Item Name: Replacement Skidtube, High Gear with Standard Wearplates Fits LH or RH

DRAWING NO. D2650	TITLE 206/407 SKIDTUBE ASSEMBLIES	REV. F	DART AEROSPACE LTD ENGINEERING ORDER		D.E.O. NO. D2650-F-1	SHEET NO. SHEET 1 OF 1	SCALE NTS
DRAWN <i>JP</i>	CHECKED <i>A.P.</i>	MFG. APPR. <i>AA</i>	APPROVED <i>#</i>		DE APPR. <i>#</i>		
DATE 12.10.12	DATE 12.10.22	DATE 12.10.22	DATE 12.10.22		DATE 12.10.22

CHANGE C'BORED WELDED CROSSBOLT SPACERS TO SWAGED SPACERS

AMENDMENT TO DETAIL B
NOT TO SCALE

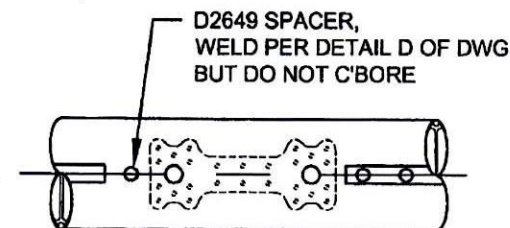
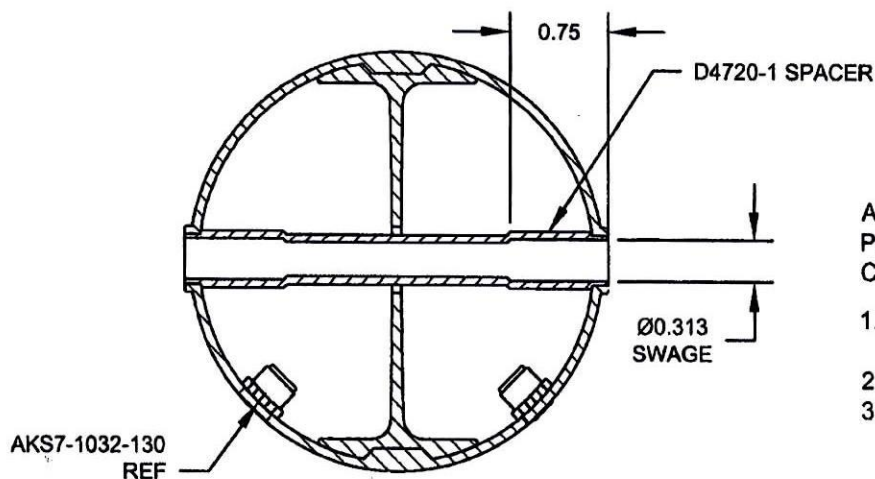
ADD DETAIL G BELOW, WHICH IS THE SAME SECTION VIEW AS DETAIL D OF DWG.

C'BORED HOLES ARE NOW SWAGED PER DETAIL G BELOW. FOR THE Ø0.375 HOLE THAT IS NOT C'BORED, WELD PER DETAIL D OF DWG (SEE AMENDED DETAIL B FOR REFERENCE).

AFTER DRILLING AND BENDING ASSEMBLY
PERFORM THE FOLLOWING FOR Ø0.375 HOLES THAT ARE
CURRENTLY C'BORED:

1. INSERT D4720-1 SPACER, 16 PL (-1) OR 17 PL (-3)
OR 19 PL (-5) OR 23 PL (-7)
2. SWAGE TO Ø0.313 X 0.75 DP PER QSI 002
3. TRIM / GRIND FLUSH PER QSI 002
